Access Compliance Report

Public Rights-of-Way

(Curb Ramps)

Intersection ID: 10022823	Main Street: CASTLE_WATCH_AV	Cross Street: N/A	Location: NE
ADA ID: 2EE386656973	Ramp Type: PerpDiag	Initial Pass/Fail: Fail	Overall Compliance: No
Severity Score: 22.5			
Codes/Mitigation Info/Possible Solution		Field Measurements/Component Compliance

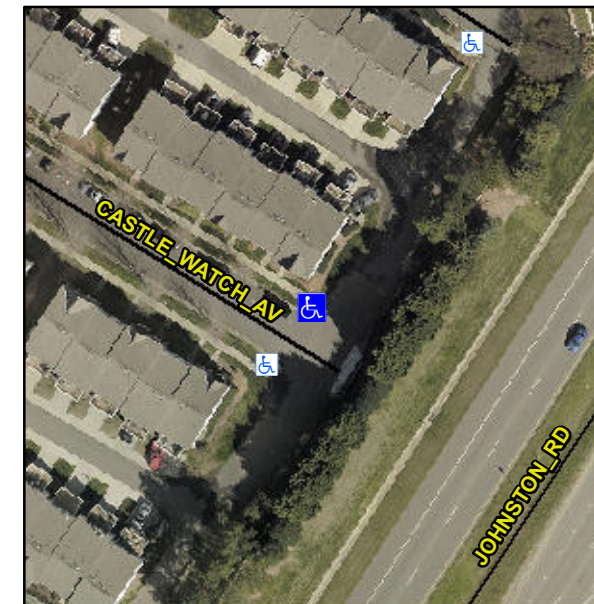
R304.5.1, R304.2.2, R304.5.3

Compliance	Description	Data	Compliance	Description	Data
N/A	Ramp Length (in)	78.0	No	Ramp Slope (%)	11.4
No	Ramp Width (in)	36.0	No	Ramp XSlope (%)	2.2
N/A	Flare Type LT	N/A	N/A	Flare Type RT	N/A
N/A	Flare Slope LT (%)	N/A	N/A	Flare Slope RT (%)	N/A
N/A	Flare Traversable LT?	N/A	N/A	Flare Traversable RT?	N/A
N/A	Landing Length (in)	N/A	N/A	DWS Provided?	N/A
N/A	Landing Width (in)	N/A	N/A	DWS Contrast?	N/A
N/A	Landing Slope (%)	N/A	N/A	DWS Length (in)	N/A
N/A	Landing X Slope (%)	N/A	N/A	DWS Full Width?	N/A
N/A	Landing Curb? (Y/N)	N/A	N/A	DWS Offset (in)	N/A
N/A	Shared Landing?	N/A			
N/A	Gutter Ponding?	N/A	N/A	Gutter Slope (%)	N/A
N/A	Gutter Lip Ht (in)	N/A	N/A	Gutter X Slope (%)	N/A
N/A	Painted X Walk1?	No	N/A	Painted X Walk2?	No
	X Walk 1 Direction	To SW		X Walk 2 Direction	To SE
N/A	X Walk 1 Width (in)	N/A	N/A	X Walk 2 Width (in)	N/A
	X Walk 1 Slope (%)	0.3		X Walk 2 Slope (%)	1.6
	X Walk 1 X Slope (%)	2.2		X Walk 2 X Slope (%)	0.3

Remove & Replace Curb Ramp With Two New Directional Ramps or Equivalent.
